# MANDATORY SERVICE BULLETIN

## NO. MSB-40-048/2

### SUPERSEDES MSB-40-048/1

### INSPECTION FOR POSSIBLE CONTAMINATION OF ENGINE FUEL SYSTEM

FUEL PRESSURE SENSOR  
(VIEW LOOKING UP)

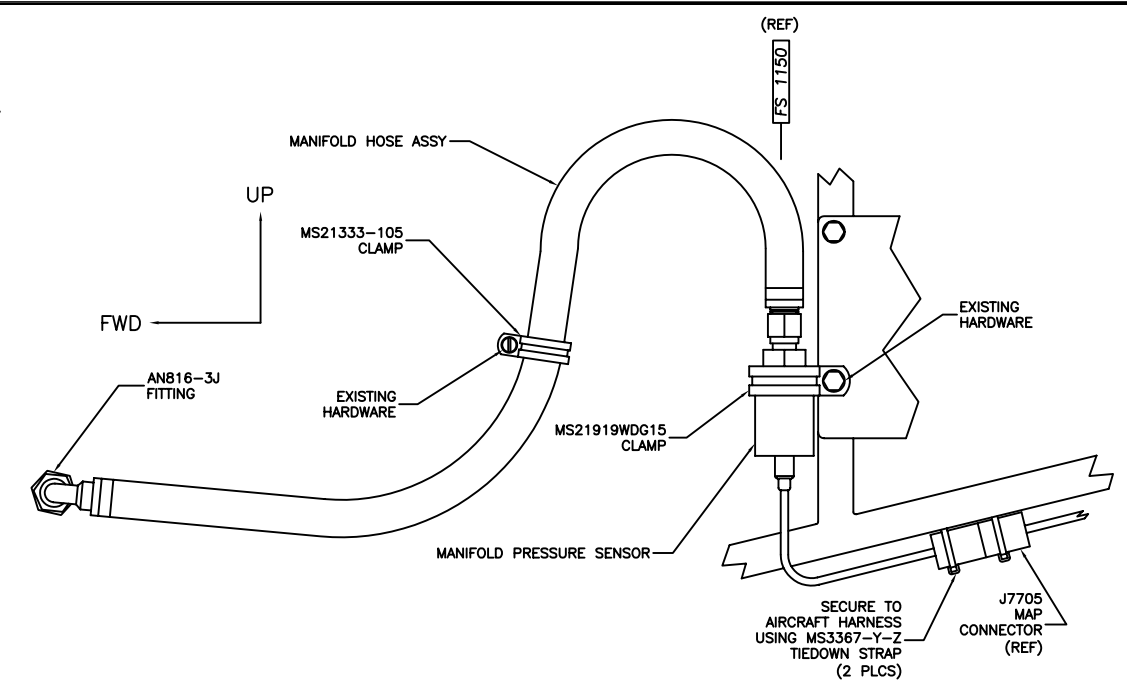
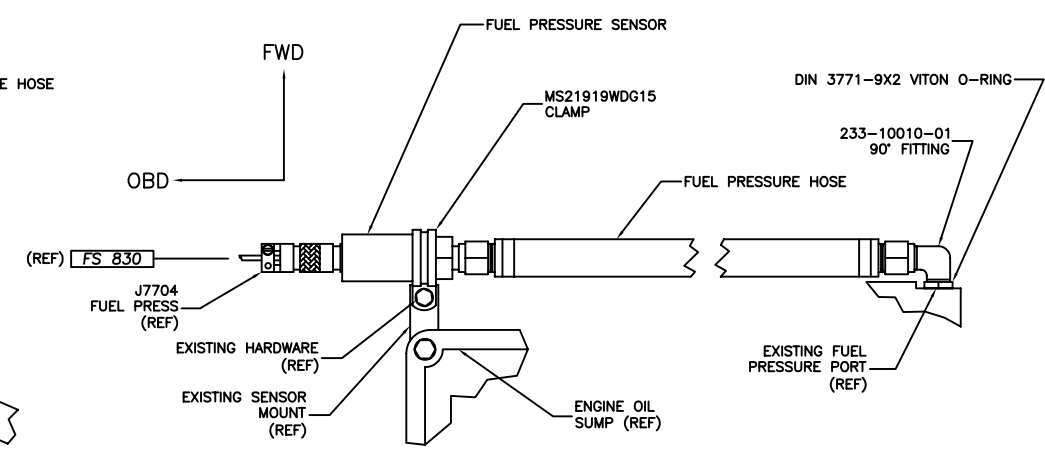
The suspect fitting is the 90 degree fuel pressure restricted port fitting. The shavings may be on the inside or outside of the parts.

1. The suspect fuel pressure fitting should have been removed when the servo was removed from the aircraft. It shall not be reused unless specifically authorized by Diamond Aircraft.

5. The fuel pressure fitting installed by Diamond mentioned previously, need to be thoroughly probed, cleaned and inspected.
6. ALL fittings and plugs in the flow divider need to be removed. Behind each of the fittings a small pocket may exist where chips can hide. All small holes in the flow divider need to be cleaned, flushed and inspected to ensure no chips are in the small passageways.

1	Install flow divider.
2	Connect stainless steel fuel lines, inlet fuel hose and vent hose to flow divider.
3	Reinstall 90° inlet fitting p/n D41-7306-00-31 with new O-Ring (P/N 951789) in servo.
4	Install new reduced flow 90° fitting p/n 233-10010-01 with new O-Ring (P/N MS29512-04) in servo.
5	Install fuel injection servo (refer to AMM Section 73-00).
